YORK COUNTY PLANNING COMMISSION

REPORT TO MUNICIPALITY OF REVIEW OF PRELIMINARY
SUBDIVISION AND LAND DEVELOPMENT APPLICATION

Re: The Village at South Mountain
91 Lots - Route 15 & Logan Road
YCPC File #27-06-11-8-571
Kairos Project No. 05008 (*Prel. Sub/LD Plan*)

The Village at South Mountain (TND)
91 Lots/236 Units – U. S. 15 & Logan Road
YPCP File #20-06-11-8-571
Kairos Project No. 05008 (Preliminary Subdivision/LD Plan)

VILLAGE AT SOUTH MOUNTAIN

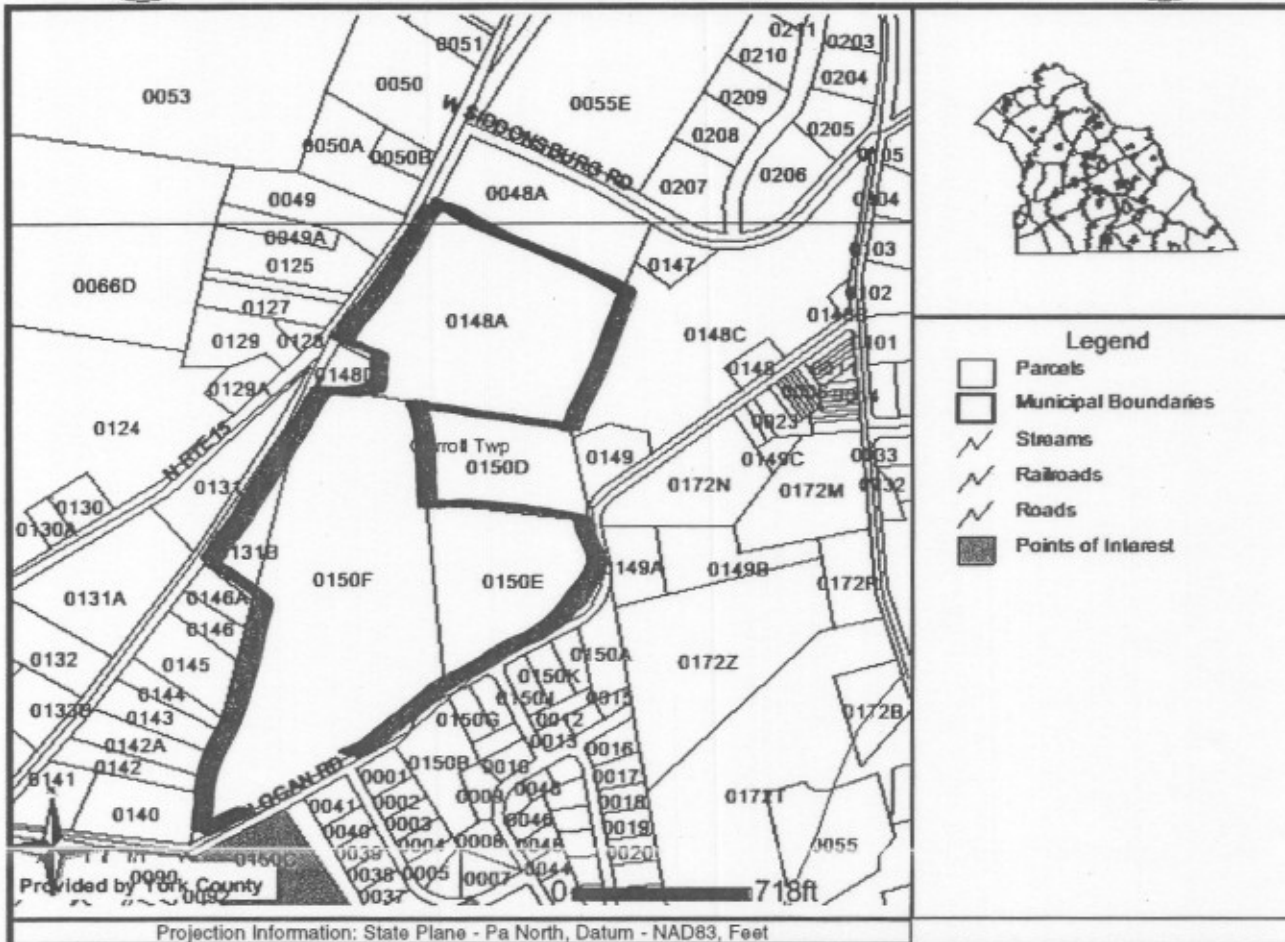
3. The adjacent property owners and deed references for the parcels (48A, 147, and 148C) to the north and east of the site are not consistent with the County Assessment Data (Please see attached map.) A number of the parcels are not consistent with what is shown on the Township Zoning Map. Verification should be provided that the adjacent property information on Sheet No. 9 is current and correct; or it should be corrected **[S. 501.c.(4)(b)]**.
